# Access Compliance Report

## Public Rights-of-Way

Intersection ID: 26115	Main Street: CARMEL_CHACE_DR	Cross Street: CARMEL_RD	Location: SW
ADA ID: 53E0C059D4BE	Ramp Type: PerpDiag	Initial Pass/Fail: Fail	Overall Compliance: No
Severity Score: 47.5			
Codes/Mitigation Info/Possible Solution		Field Measurements/Component Compliance

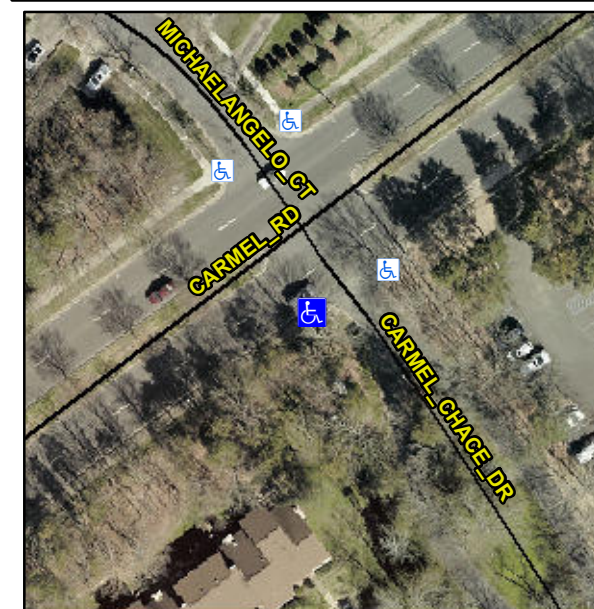
**Not Found, R304.5.1, R304.2.2**

Compliance	Description	Data	Compliance	Description	Data
N/A	Ramp Length (in)	59.0	No	Ramp Slope (%)	10.3
No	Ramp Width (in)	31.0	Yes	Ramp XSlope (%)	0.6
N/A	Flare Type LT	N/A	N/A	Flare Type RT	N/A
N/A	Flare Slope LT (%)	N/A	N/A	Flare Slope RT (%)	N/A
N/A	Flare Traversable LT?	N/A	N/A	Flare Traversable RT?	N/A
N/A	Landing Length (in)	N/A	N/A	DWS Provided?	N/A
N/A	Landing Width (in)	N/A	N/A	DWS Contrast?	N/A
N/A	Landing Slope (%)	N/A	N/A	DWS Length (in)	N/A
N/A	Landing X Slope (%)	N/A	N/A	DWS Full Width?	N/A
N/A	Landing Curb? (Y/N)	N/A	N/A	DWS Offset (in)	N/A
N/A	Shared Landing?	N/A			
N/A	Gutter Ponding?	N/A	N/A	Gutter Slope (%)	N/A
N/A	Gutter Lip Ht (in)	N/A	N/A	Gutter X Slope (%)	N/A
N/A	Painted X Walk1?	No	N/A	Painted X Walk2?	No
	X Walk 1 Direction	To E		X Walk 2 Direction	To N
N/A	X Walk 1 Width (in)	N/A	N/A	X Walk 2 Width (in)	N/A
	X Walk 1 Slope (%)	0.2		X Walk 2 Slope (%)	1.1
	X Walk 1 X Slope (%)	3.1		X Walk 2 X Slope (%)	1.7

**Remove & Replace Curb Ramp With Two New Directional Ramps or Equivalent.**
